## REVISED RESPONSE TO REQUEST FOR ADDITIONAL INFORMATION

### APR1400 Design Certification

Docket No. 52-046

**RAI No.:** 248-8295  
**SRP Section:** 03.08.05 - Foundations  
**Application Section:** 3.8.5  
**Date of RAI Issue:** 10/14/2015

Figure 3.8-57 Rebar Arrangement of Containment Dome

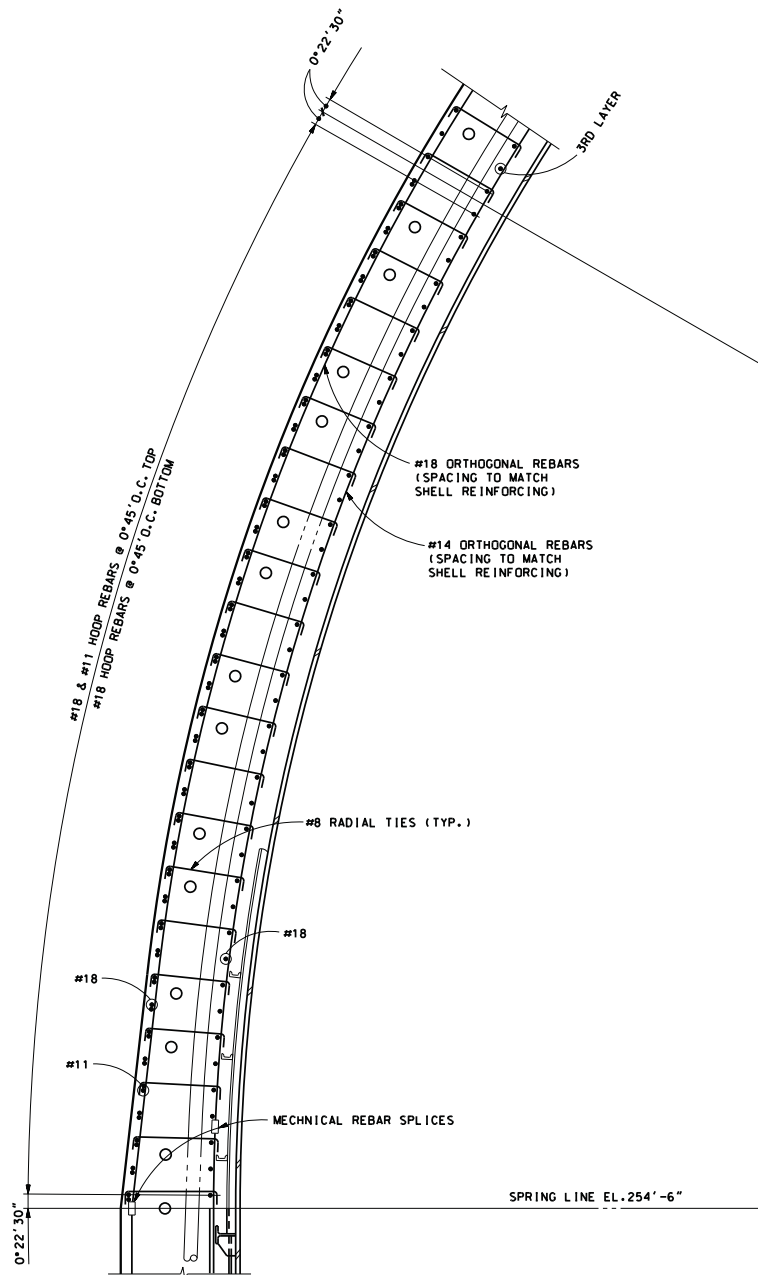
- a. Whether any other critical sections such as the dome; steel plate liner to the containment; floor slab between the SSW and the containment, and a steel beam and/or column; and mainsteam and feedwater penetrations are identified as critical sections. If so, the applicable portion of the DCD should be updated accordingly.

In the list of critical design sections in DCD Tier 2, Section 3.8A.1.4.1.3.5, containment dome and liner plate/anchorage are missing. The design forces and moments, design results, and margin of safety for the containment dome will be added to DCD Tier 2, Sections 3.8A.1.4.1.3.4 through 3.8A.1.4.1.3.7, and the corresponding figures and tables, as shown in Attachment 1 to this response. For the containment liner plate and anchorage, the design procedure and criteria are described in Section 3.8.1.4.10. The design results, including the margin of safety, are presented in Table 3.8-12 in the DCD. A more detailed description of the design approach, procedure, and criteria will be expanded upon in DCD Tier 2, Section 3.8A.1.4.1.3.8, as shown in Attachment 1 to this response.

[3.8A.1.4.3.4](#), [Tables 3.8A-41 through 3.8A-46](#), and [Figure 3.8A-57](#) will be also added for additional information.

Figure added
